OC PLANNING REPORT

SUBJECT: Public Hearing on Planning Application PA19-0248 for a Coastal Development Permit and Variance approvals

PROPOSAL: A request for a Coastal Development Permit and Variance approval to permit the expansion of an existing cantilevered deck area to extend to within 6 feet of the rear property line where Zoning would require a setback of 18.4 feet (by shallow lot criteria) and to permit the addition of an additional story consisting of a 370 square foot studio guesthouse (with bathroom, no kitchen).

LOCATION: The project is located at 923 Emerald Bay, Laguna Beach, in the community of Emerald Bay and within the Fifth Supervisorial District. (APN: 053-023-03)

Front Elevation

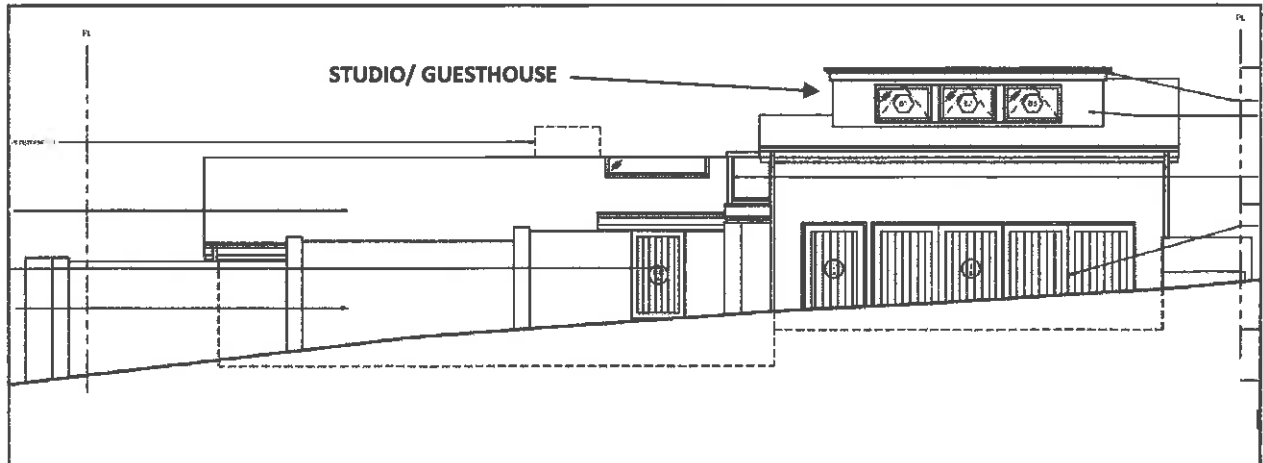
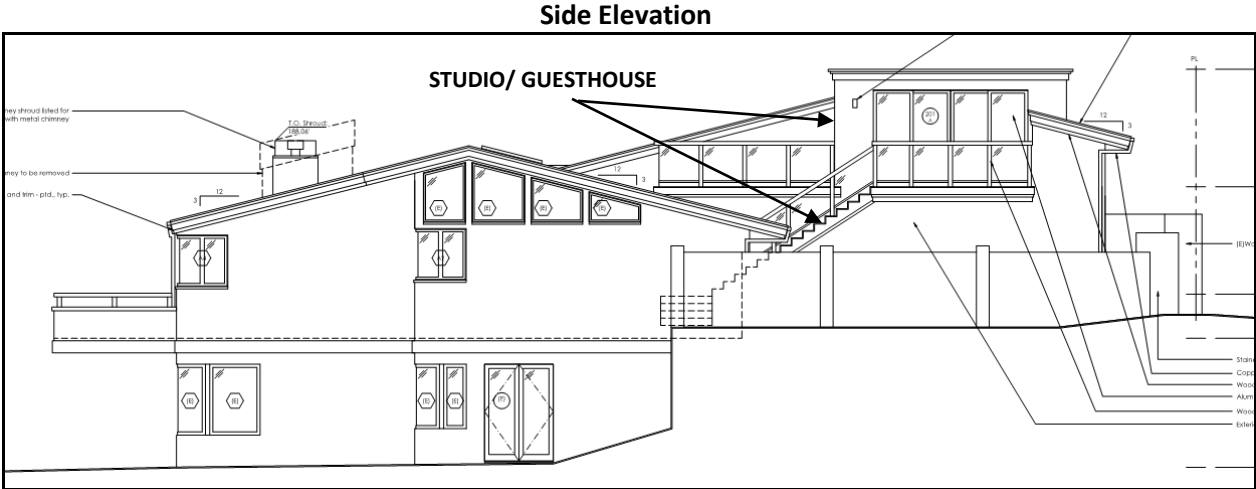
The project is compatible with surrounding development in its size, design and massing. The subject property is not within the ‘appealable jurisdiction’ area of the LCP.
